Historic Preservation Commission

March 10, 2022

Certificate of Appropriateness

1630 Park Avenue SE – new garage

Project

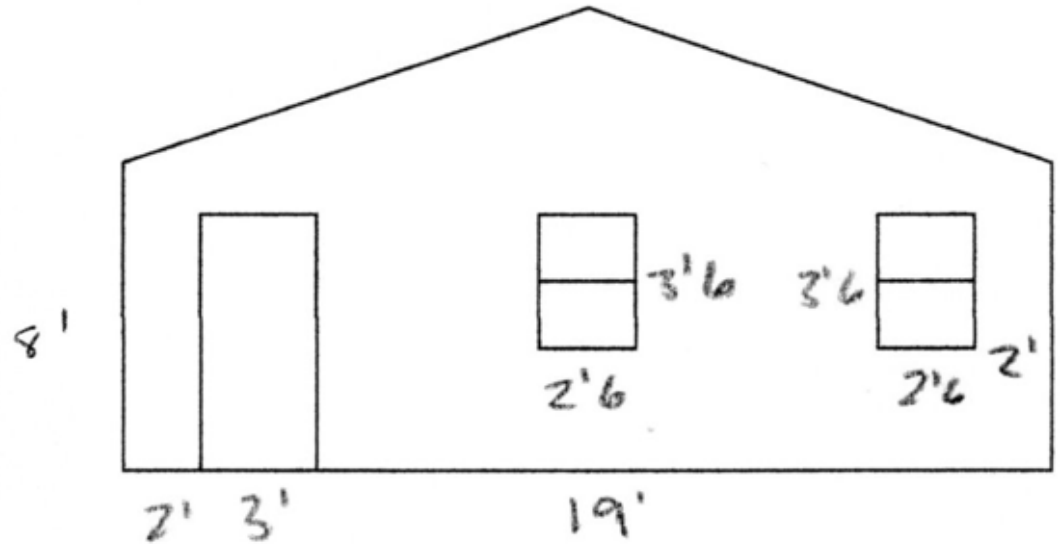
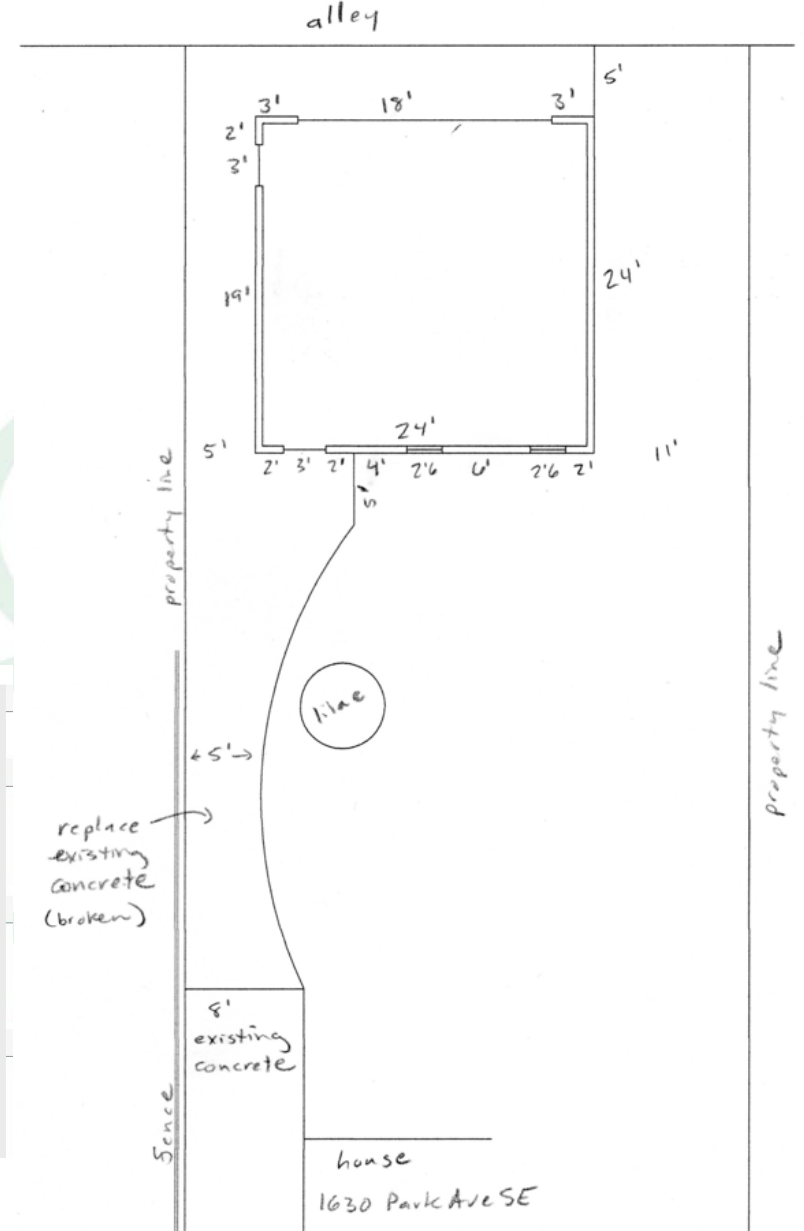
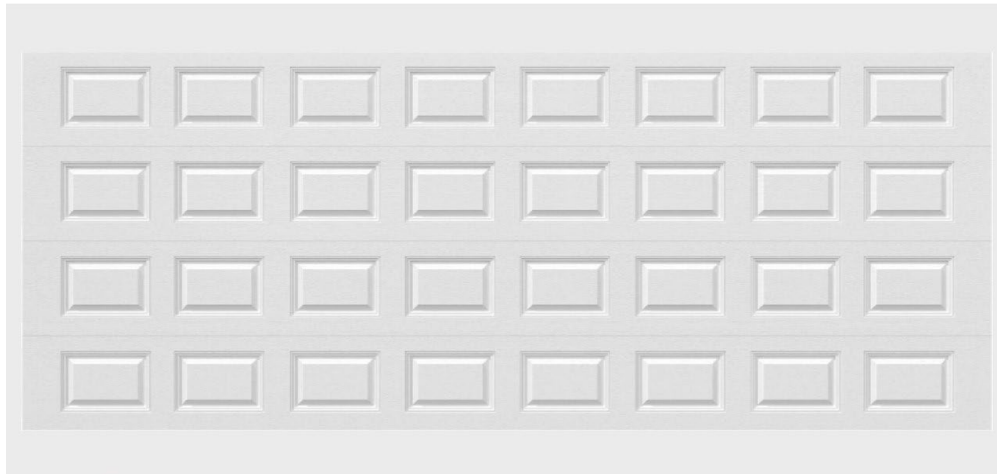
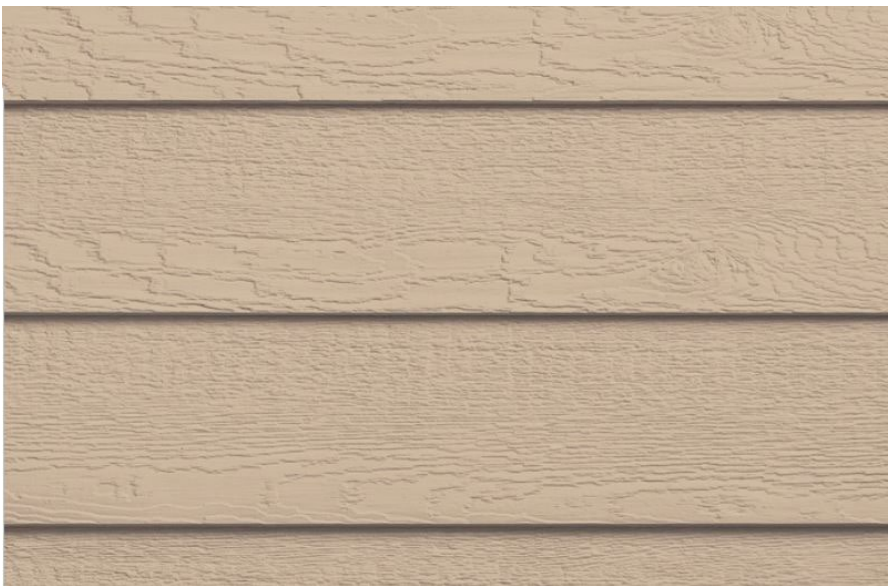
- New accessory structures should be compatible with primary buildings.
- A new secondary structure should be subordinate in height to primary structures seen along the street front.
- A secondary structure of no more than one-and-one-half stories in height is preferred.
- Locate a secondary building to the rear of the lot.
- Locating a secondary structure to the side of the primary structure, but set back significantly from the front wall plane.
- A secondary structure should be oriented similar to those seen traditionally along the alley.
- A garage should be located off an alley where possible.
- On a lot where a garage must be accessed from the street, set it back from the front wall plane of the primary structure.

- Locating a garage such that it is visually prominent.
- Secondary structures with incompatible building design or materials.

- Staff recommends approving the Certificate of Appropriateness because it aligns with the design guidelines for new construction.
